DOCUMENTATION TRANSMITTAL

Documentation Description: Nonconformance Reports - C-002241-V & C-02243-V

## NONCONFORMANCE REPORT

1 ITEM LOCATION  
SERVICE WATER PUMP STRUCTURE WALLS

NORTH FACE/SOUTH WALL ELEVATION (WATER WALL)

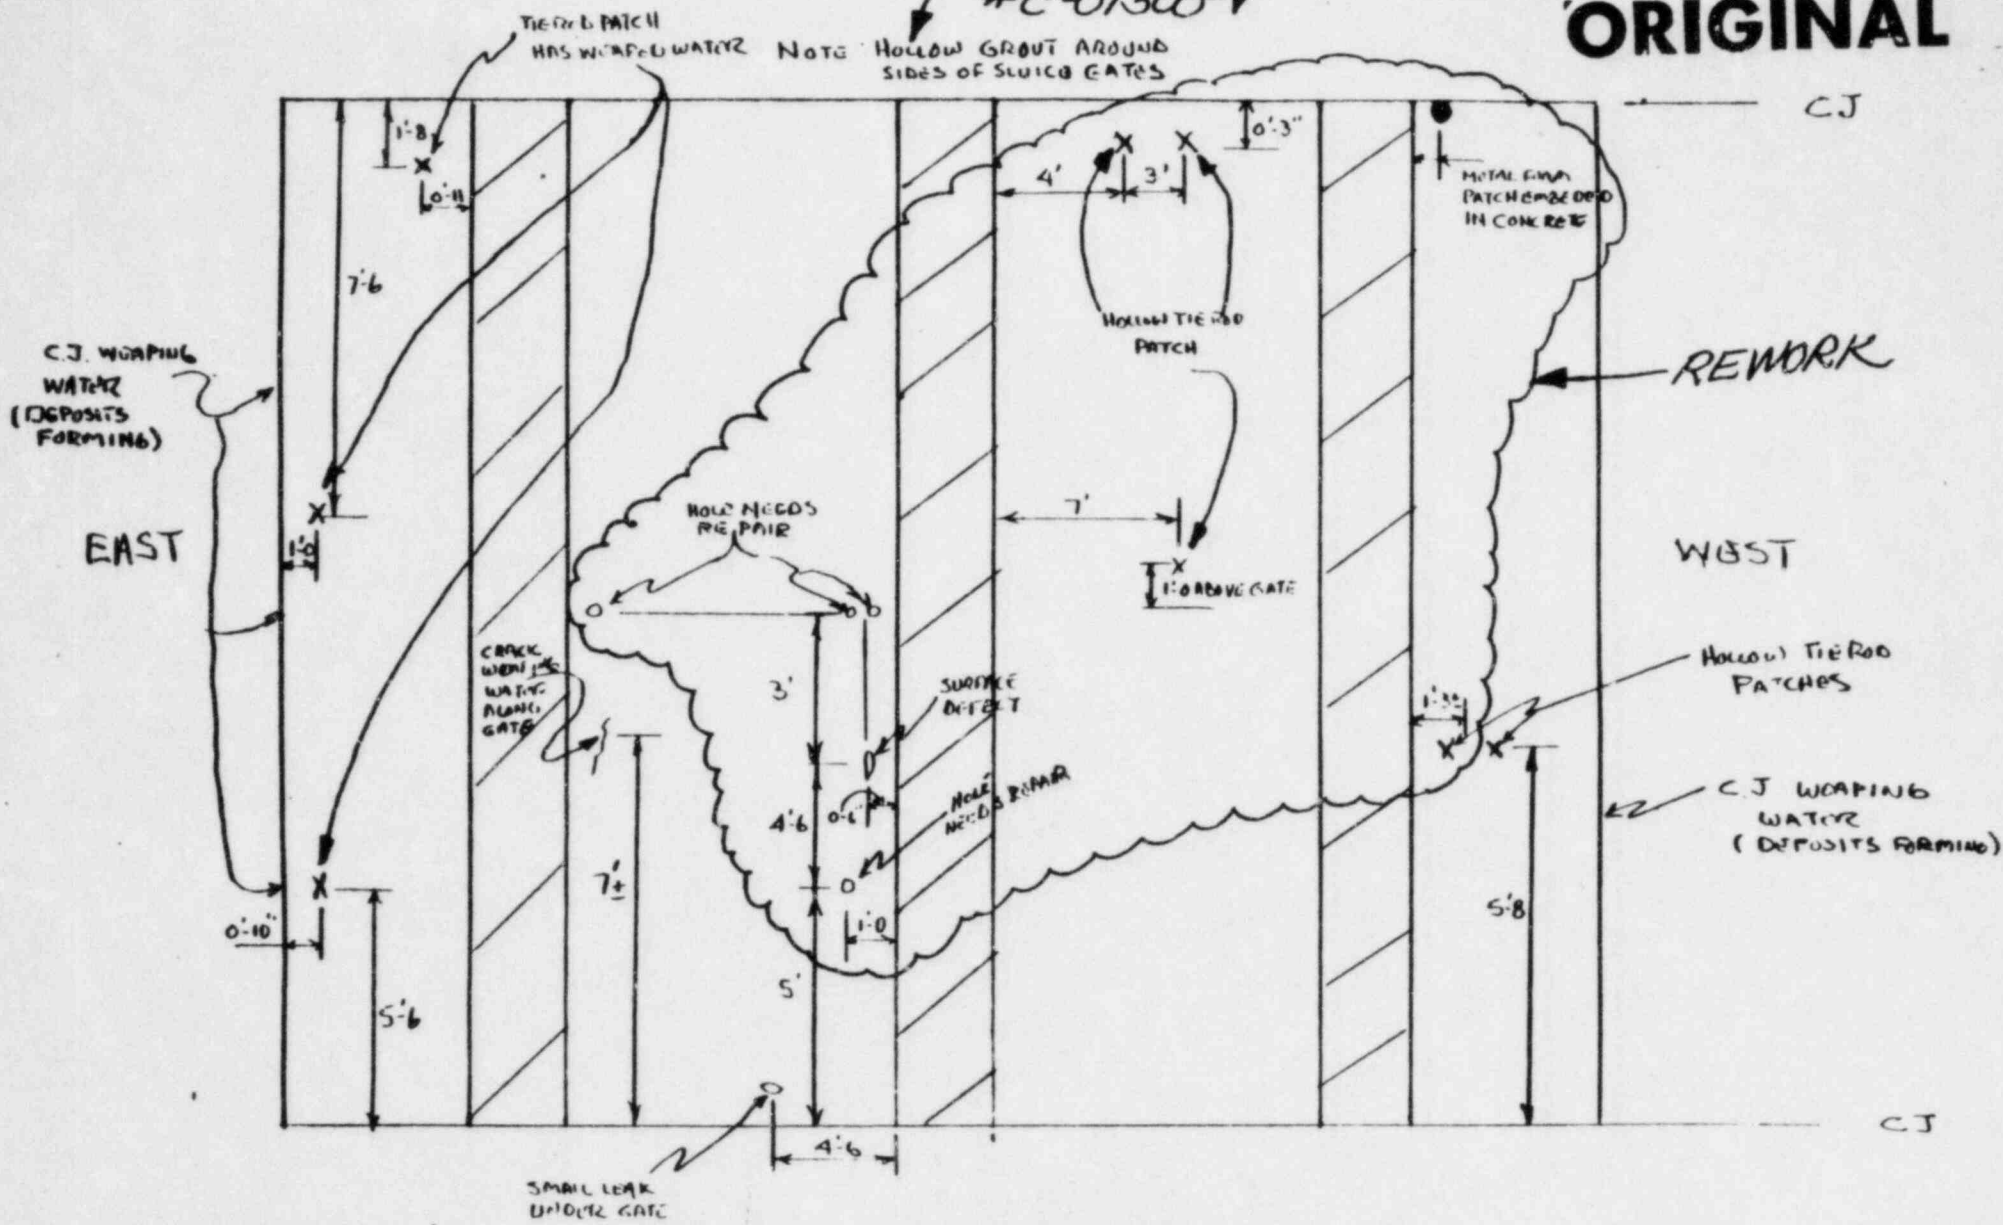
SEE NCR  
#C-01308-V

IOA Project Engineering concurs with field engineering and recommends "REWORK" in the areas shown <sup>UP</sup> according by ~~spec~~ according to spec C-231 sect 17 4-27-84

IOB The tie rod patches at 1'-8" 7'-6" and 5'-6" from ~~the~~ THE C-Joints were found to be solid. A little moisture leakage will not affect structural integrity. The leakage will stop when hydrostatic pressure equalizes due to filling of water in the SWPS. Project Engineering recommends "USE AS IS" 4/13/84

IOC The crack weeping along the gate - The crack <sup>will</sup> build up calcium carbonate and stop leaking. This is a normal process in any marine structure. Project engineering recommends "USE AS IS" since that crack will be monitored by remedial soils group. See TOM from B Dhar to J. Hockwater dated 4-26-84 Com 149308 (See attached) 4/27/84

IOD The tie rod hole 5'-6" above C-J ~~was~~ <sup>is</sup> ~~found~~ <sup>to be</sup> ~~hollow~~ <sup>UP</sup> upon physical review. ~~The~~ disposition should be "USE AS IS" "INVALID" ~~OR~~ <sup>UP</sup> THE PATCH IS STRUCTURALLY SOUND. 4/30/84

IOD UPON PHYSICAL REVIEW, THE TIE ROD HOLE 5'-6" ABOVE THE CONSTRUCTION JOINT, IS FOUND TO BE STRUCTURALLY SOUND. P.E. DISPOSITION IS THAT THIS NONCONFORMANCE IS "INVALID". USE AS IS 8W 4/31/84

IDE The const joint <sup>DATE 4/20/84</sup> ~~will~~ stop leaking after formation of calcium carbonate and equalization of hydrostatic pressure. This is a normal process in any marine structure. <sup>DATE 4/20/84</sup> ~~Additionally~~ <sup>ADDITIONALLY</sup> this area will be monitored by remedial soils group for crack surveys. See Form from B. Dhar to J. Hockwater dated 4/26/84 (Chron # 149300) <sup>DATE 4/30/84</sup> SEE PAGE 19. Project Engineering recommends "USE AS IS"

IDF The small leak under gate B due to tie rod patch and will stop when hydrostatic pressure equalizes. It does not affect structural integrity. The disposition is "USE AS IS"

SOUTH ELEVATION SLUICE GATE WALL

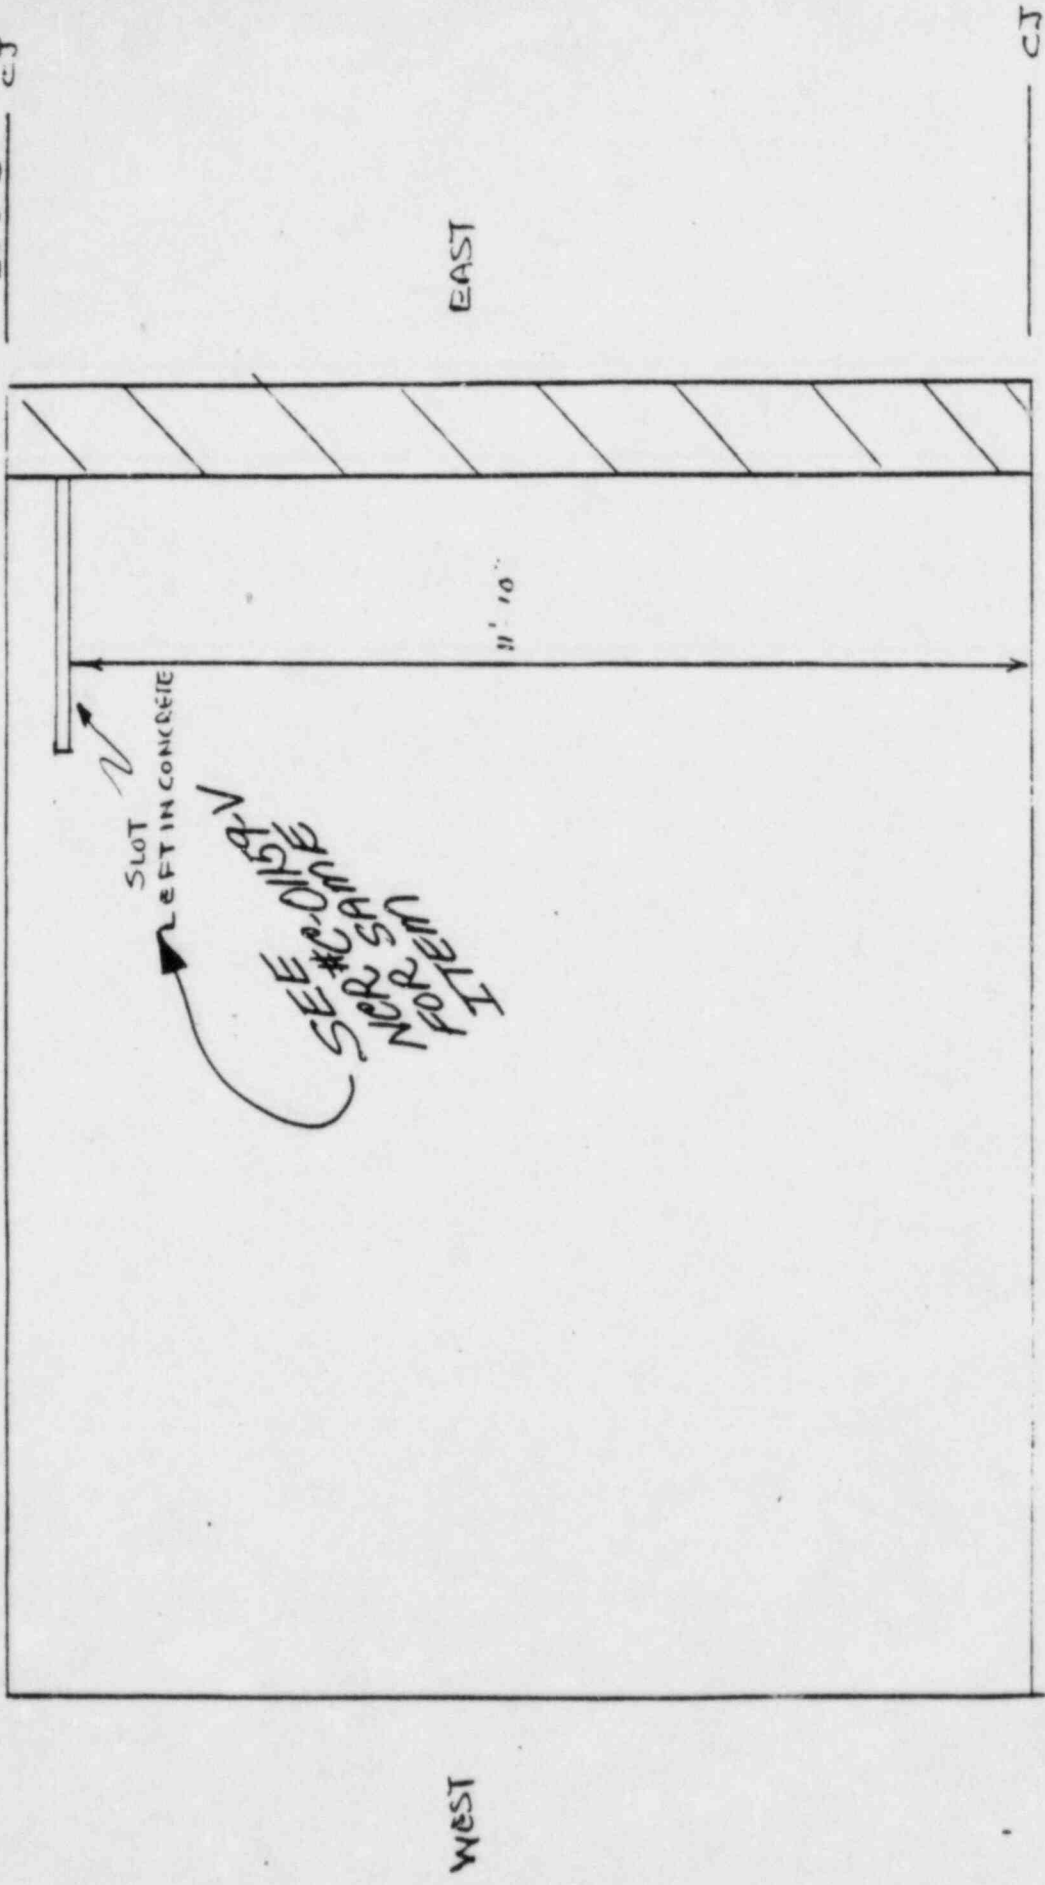
SEE #C-0159-V  
NCR SAME  
FOR ITEM  
I

IIA Project engineering concurs with field engineering and recommends "rework" in areas shown by clouding ~~and~~.

II B The hollow tie rod patch, upon physical review was found to be not hollow. Project Engineering's ~~recommends "USE AS IS"~~ <sup>DATE 4/20/84</sup> ~~DISPOSITION IS~~ <sup>DATE 4/20/84</sup> ~~THAT THE~~ NONCONFORMANCE IS ~~INITIAL~~ <sup>DATE 4/20/84</sup> ~~USE AS IS~~ <sup>DATE 4/20/84</sup> ~~SW~~ STRUCTURALLY SOUND.

WEST ELEVATION (FOLD OUT)

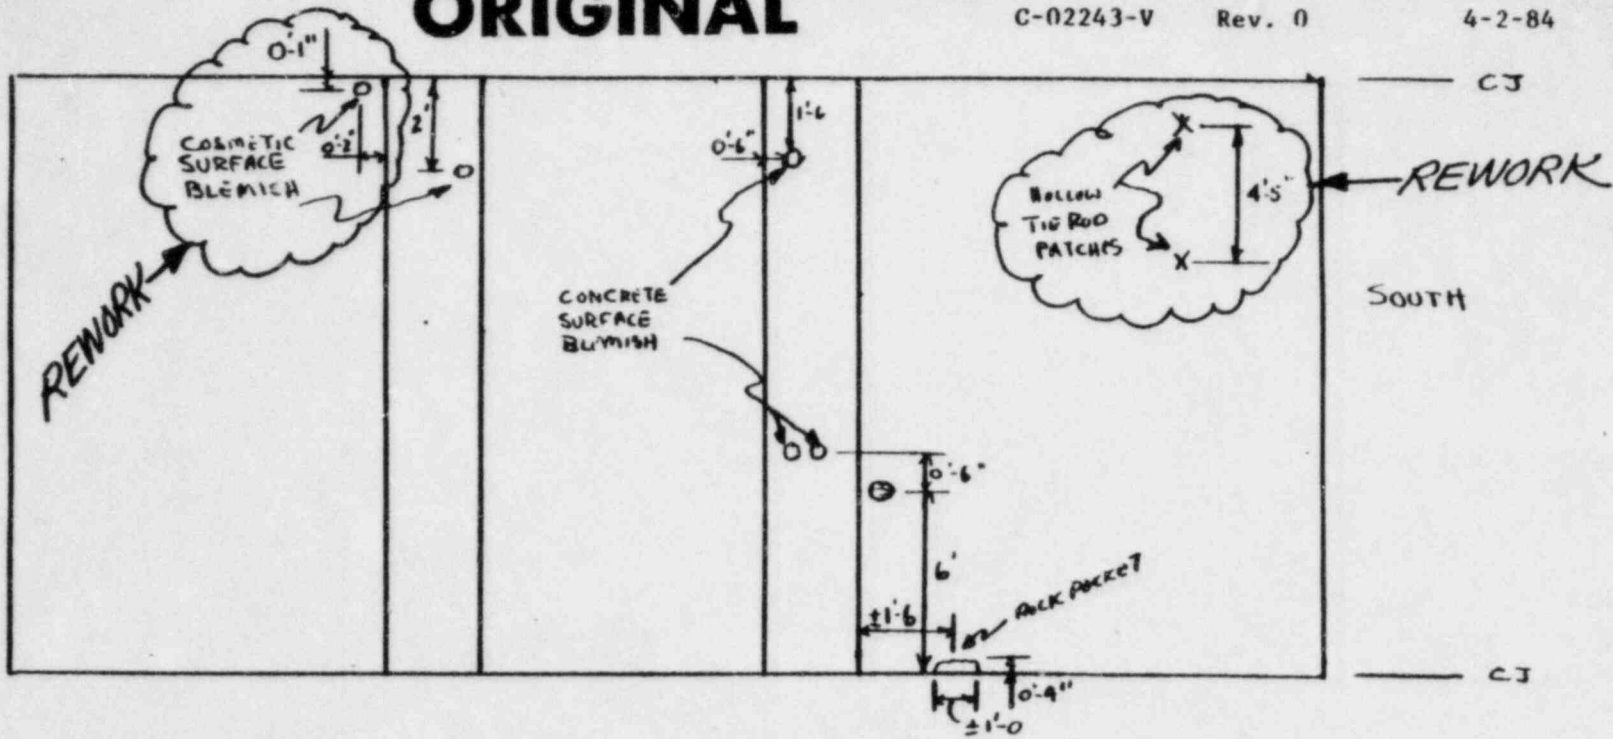
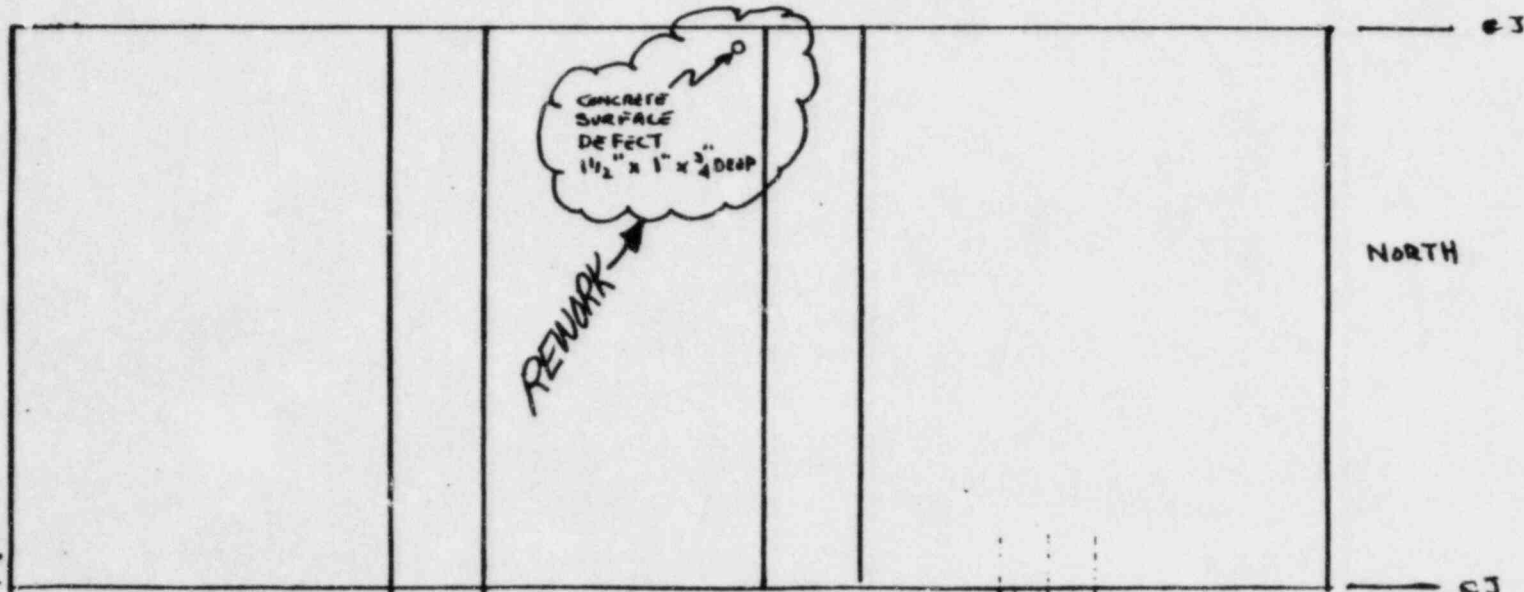
O = SURFACE IMPERFECTIONS

14A Project Engineering concurs with field engineering and recommends "REwork" in areas shown by clouding on page 14. Rework according to spec C-231 sect 17

14B The concrete surface blemishes referred are of a non structural nature and give roughness to concrete. Spec C-231 sect 17.1 now requires "texture of concrete" to be "not a quality control inspection item" Project engineering. DISPOSITION IS TO "USE AS IS" - <sup>4.26.84</sup> ~~4.30/84~~ for this nonconformance see

14C The rock pocket was of minor nature. Physical review indicated that it was of no structural importance and did not damage the structural integrity. The recommended disposition is "USE AS IS"

SWPS SWI# (6345)d

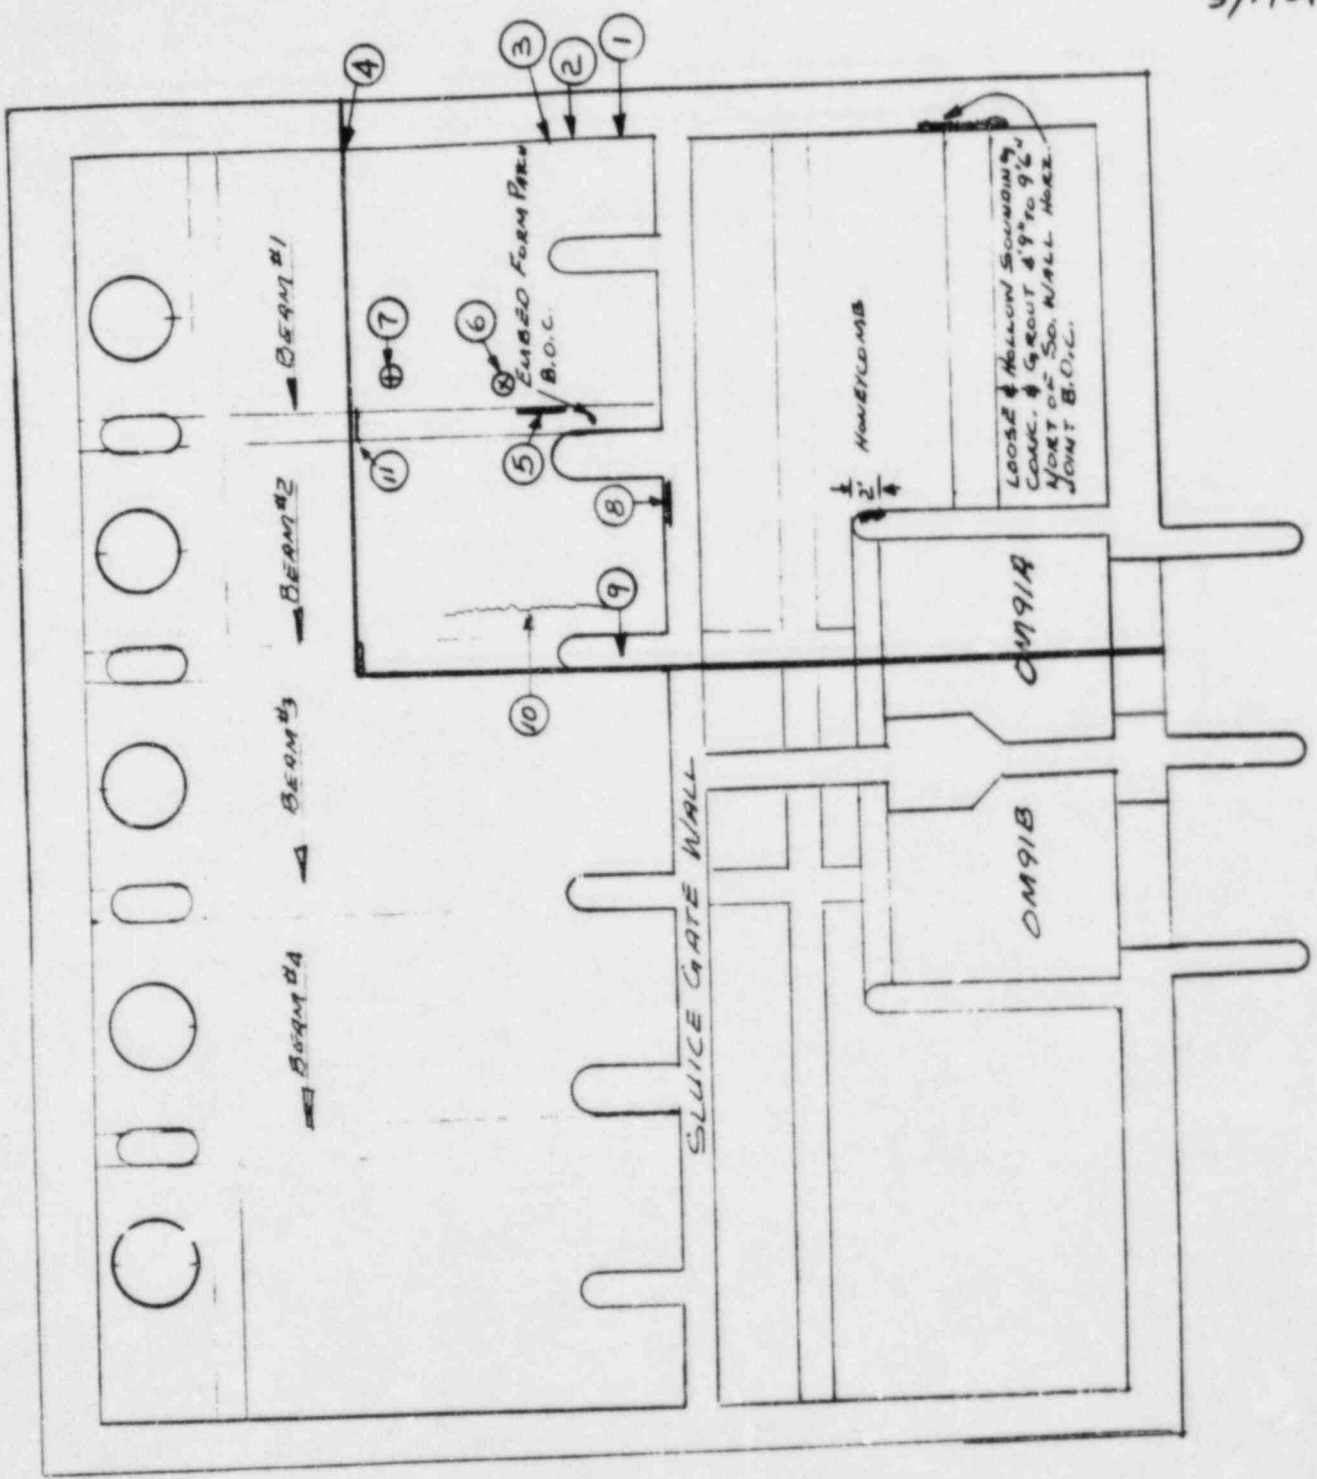
13 NONCONFORMANCE SEE ATTACHED SKETCH FOR THE PROXIMITY OF DEFECTS AS LISTED BELOW: IN THE WEST FACE OF EAST WALL @ ELEV 629 1/2' ± 4'9" TO 9'6" NORTH OF SOUTH WALL IN THE HORIZ. CONST. JOINT, LOOSE & HOLLOW SOUNDING GROUT & CONCRETE.  
ON THE EAST FACE OF EAST BULK HEAD OF SLUICE GATE OM 91A @ ELEV 628 ± TO 6'30" ± @ NORTH END OF BULK HEAD, HONEYCOMB AREA, EMBED FORM PATCH BOTTOM OF BEAM #1 3' ± NORTH OF SLUICE GATE WALL.

- ① EMBED WOOD S.E. CORNER OF RM#101, 6" BELOW CEILING ON WEST FACE OF EAST WALL  
3'6" NORTH OF THE SLUICE GATE WALL
- ② HONEYCOMB ON WEST FACE OF EAST WALL FROM 4' NORTH TO 8' NORTH OF SLUICE GATE  
WALL @ ELEV 630' TO 633'

- ③ TRASH & <sup>DEBRIS,</sup> ROCK POCKET IN THE WEST FACE OF THE EAST WALL FROM 6'4" NORTH TO 9'10"  
NORTH OF THE SLUICE GATE WALL @ ELEV 630' TO 633'

- ④ CRACKED VERTICAL CONSTRUCTION JOINT 18' NORTH OF THE SLUICE GATE WALL
- ⑤ HONEYCOMB IN THE EAST FACE OF BEAM #1, 3' TO 9' NORTH OF SLUICE GATE WALL
- ⑥ COSMETIC REPAIR ON GROUTED PENETRATIONS IN CEILING 9'4" NORTH OF SLUICE  
GATE WALL 6" EAST OF BEAM #1

- ⑦ SAME AS #6 ABOVE 14' ± NORTH OF SLUICE GATE WALL 12" EAST OF BEAM #1
- ⑧ SAND POCKET IN BOTTOM OF LIFT IN THE NORTH FACE OF THE SLUICE GATE WALL  
FROM WEST EDGE OF BEAM #1 TO 2 1/2' WEST OF BEAM (TO EAST EDGE OF BACKLIFT)

- ⑨ DEBRIS IN BOTTOM OF BEAM #2 FROM SLUICE GATE WALL TO 2' TO 3' NORTH.
- ⑩ CRACKED SLAB FROM NORTH FACE OF SLUICE GATE WALL TO 12' ± NORTH,  
PARALLEL & 1' EAST OF BEAM #2

- ⑪ CRACKED BEAM & DEBRIS @ CONSTRUCTION JOINT OF BEAM #1 18' NORTH  
OF THE SLUICE GATE WALL

- ⑤ REWORK (PORTION); THREE (3) CAVITIES EXCEED  $\frac{1}{2}$ " DEPTH AND TO BE FILLED PER SPEC C-231, SECTION 17.0.  
USE-AS-IS (BALANCE); BUG HOLES, NOT HONEYCOMB.
- ⑥ USE-AS-IS; "COSMETIC" CONDITION ONLY.
- ⑦ USE-AS-IS; "COSMETIC" CONDITION ONLY.
- ⑧ CORRECT LOCATION TO READ "WEST EDGE OF BEAM #2" IN LIEU OF "BEAM #1": USE-AS-IS; ~~REWORK~~ SURFACE IMPERFECTION ONLY.
- ⑨ TWO (2) SMALL ~~PIECES~~ PIECES OF PAPER (GUM WRAPPERS) EMBEDDED AT SURFACE: REWORK; REMOVE EMBEDDED DEBRIS.
- ⑩ ~~REWORK~~ USE-AS-IS; CRACKS NOT ADDRESSED IN SPEC C-231.
- ⑪ REWORK (DEBRIS); REMOVE DEBRIS (SAND/SAWDUST) FROM CONSTRUCTION JOINT ~~REWORK~~
- ~~REWORK~~ USE-AS-IS (CRACKS); CRACKS NOT ADDRESSED IN SPEC C-231.

Item A - In the west face of east wall @  
EG 629 1/2' ---

Project Engineering concurs with field engineering that the non conformance described should be "REWORK" according to Spec C-231

The item described upon physical review was found to be air voids. Form coatings applied in thick layers tend to hold the air bubbles to the form work. These air voids are of no structural consequence. The structural integrity of the building is not impaired. Project engineering recommends USE AS IS

Project Engineering concurs with field engineering and recommends "REWORK" for this item according to spec C-231. Remove form patch as necessary SW

Item 8 The location of the non-conformance is incorrectly described. The location should read "west edge of beam # 2". Physical review indicated that there was no sand pocket. Some surface imperfections were found which rendered this area rough. Project engineering recommends "USE AS IS" since these imperfections do not affect structural integrity.

Item 9 Project engineering concurs with field engineering and recommends "REWORK" according to spec C-231 as necessary.

Item 11 (IA) Project engineering concurs with field engineering and recommends "REWORK" THE DEBRIS <sup>IN THE</sup> ~~AND~~ <sup>OPIL.</sup> for construction joint <sup>IDENTIFIED</sup> ~~OPIL~~ Remove all debris and rework according to spec C-231

(IB) The crack in the beam will be monitored by remedial soils group. See IOM from B. Akar to J. Hockwater dated 4-26-84 Com 149308 page 11 of this NCR.) P.E. DISPOSITION IS TO "USE AS IS".

These areas will be repaired <sup>"REWORKED"</sup> Remaining areas <sup>(5B)</sup> were air voids left due to excessive application of form coatings. These air voids do not affect the structural integrity. Project engineering recommends "USE AS IS" for these areas in item 3 SB 4/18/84. For item 3B no rock pockets were found and the recommended disposition is ~~"USE AS IS"~~ <sup>"INFACT"</sup> USE AS IS <sup>SW</sup>.

Item 2 Physical review indicated that the area had air voids due to excessive application of form agent used for form separation. These air voids do not affect structural integrity. Project engineering recommends USE AS IS.

Item 4, 10 The cracks identified in these items will be monitored by remedial soils group. See attached IOM from B Dhar to J. Hoekwater dated 4-26-84 Com # 149308 (page 11 of this NCR) The disposition is "USE AS IS".

Item 6, 7 <sup>NONCONFORMANCE STATEMENTS</sup> The ~~statements~~ indicated that these areas need cosmetic repairs. Physical review indicated that these areas have rough finish. Since they do not affect structural integrity the disposition is "USE AS IS".
